Serial: HNP-06-089
10 CFR 50.90

SHEARON HARRIS NUCLEAR POWER PLANT, UNIT NO. 1
DOCKET NO. 50-400/LICENSE NO. NPF-63
REQUEST FOR LICENSE AMENDMENT
TO REVISE VALUES ASSOCIATED WITH THE STEAM GENERATOR WATER
LEVEL (SGWL) TRIP SETPOINTS

SHEARON HARRIS NUCLEAR POWER PLANT, UNIT NO. 1
DOCKET NO. 50-400/LICENSE NO. NPF-63
REQUEST FOR LICENSE AMENDMENT
DESCRIPTION, BACKGROUND, AND TECHNICAL ANALYSIS

FIGURE 2

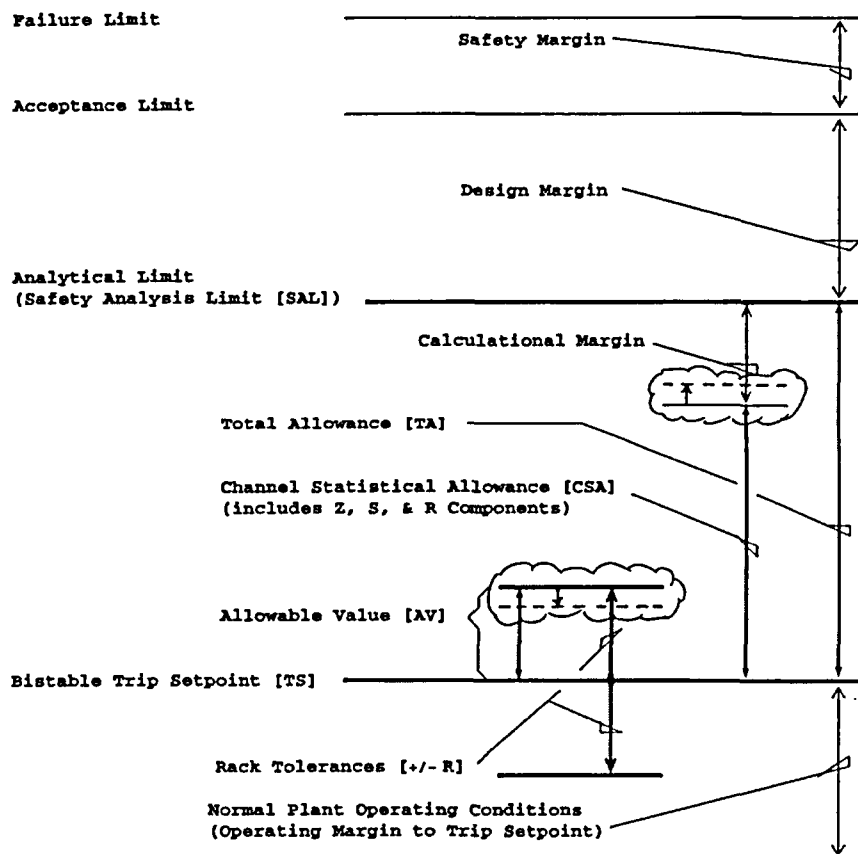
For clarity, Figure 2 below provides a simplified graphical representation (clouded areas) of the increases in the statistical summation error term "Z," which slightly reduces the calculation margin, and the effective decrease in the allowable value for one of the SGWL trip setpoints.
